# **Mobile Intel<sup>®</sup> Pentium<sup>®</sup> II Processor Specification Update**

Release Date: April 2005

Order Number: 243887-048

The Mobile Pentium<sup>®</sup> II processor may contain design defects or errors known as errata which may cause the product to deviate from published specifications. Current characterized errata are documented in this Specification Update.

**Figure 1. An Example of Microcontroller Driven Thermal Management**

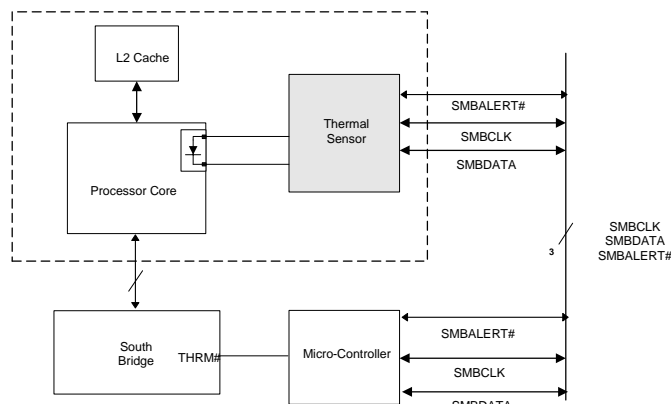
**Problem:** The Mobile Pentium II processor and the Pentium II Processor Mobile Module have a thermal sensor that monitors the processor core's temperature. Please note that desktop systems could have a similar thermal device. The thermal sensor asserts SMBALERT# if the processor temperature exceeds the temperature limits set in the Alarm Threshold Registers ( $T_{HIGH}$ ,  $T_{LOW}$ ). It also sets the corresponding Status Register bits to identify the cause of the interrupt. Figure 1 gives one example of how the SMBALERT# signal could be used in a system.

**Figure 2. Workaround Flowchart: SMBALERT#-Driven System**

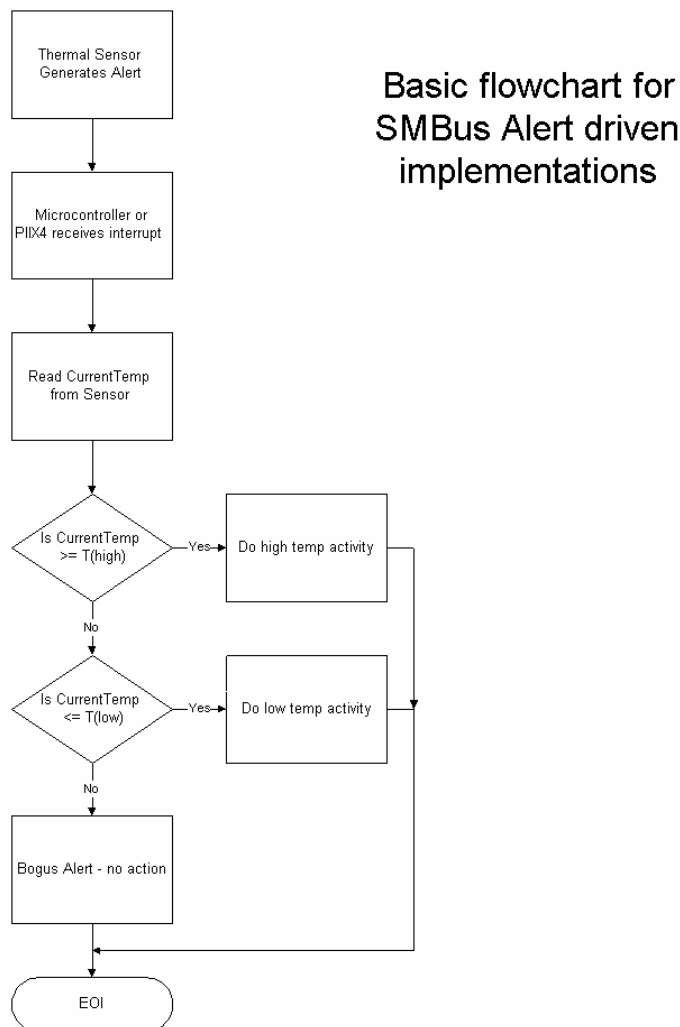
Under the conditions described below, the thermal sensor incorrectly generates the SMBALERT# interrupt. All of the following conditions must be met to trigger a false interrupt:

1. Before servicing an interrupt from the thermal sensor, read and compare the processor thermal reading with the threshold limits ( $T_{HIGH}$  or  $T_{LOW}$ ). Figures 2 and 3 provide basic flowcharts for the implementation of this workaround in an interrupt driven system.
2. If the firmware implemented polls the Status Register only, then before taking any action, re-read the temperature register and do a comparison with the alarm threshold limits ( $T_{HIGH}$  or  $T_{LOW}$ ) to determine if the value is actually still within the temperature window.

3. Use a temperature polling scheme to monitor the processor temperature.

Figure 1. TAP Gageable Thread Clarification

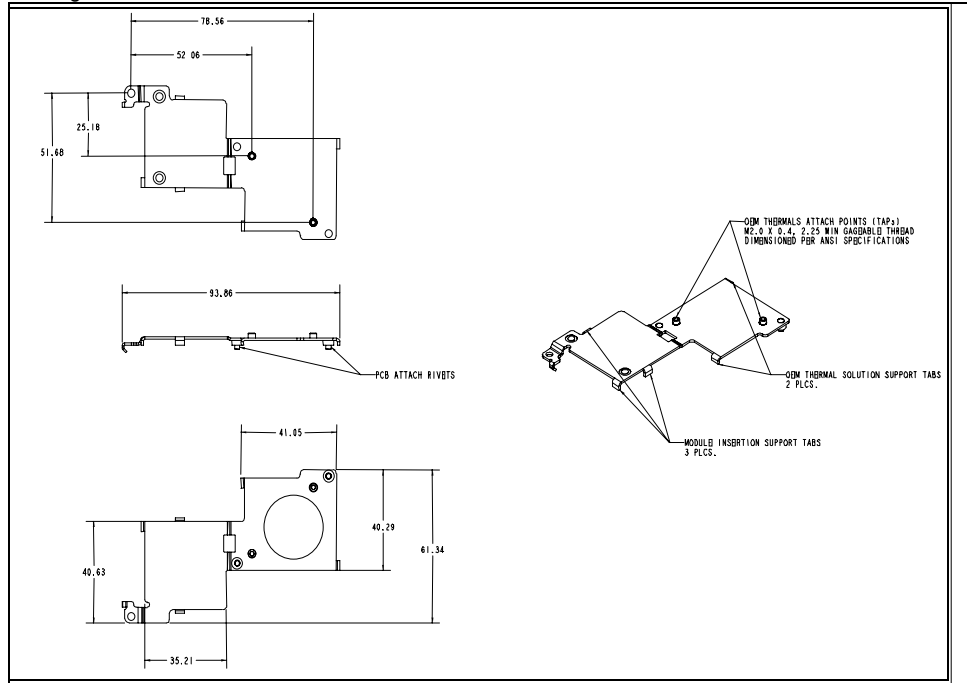
In the *Intel® Pentium® II Processor Mobile Module : Mobile Module Connector 1 (MMC-1)* and the *Intel® Pentium® II Processor Mobile Module : Mobile Module Connector 2 (MMC-2)* datasheets (Order Numbers 243667 and 243668, respectively), the thermal attach point (TAP) gageable thread specification was not clearly identified in Figure 14, of Section 5.2. The following is the TAP clarification:

OEM Thermal Attach Points (TAPs) M2.0 x 0.4, 2.25 min gageable thread dimensioned per ANSI specification.

See Figure 1 below for more information.
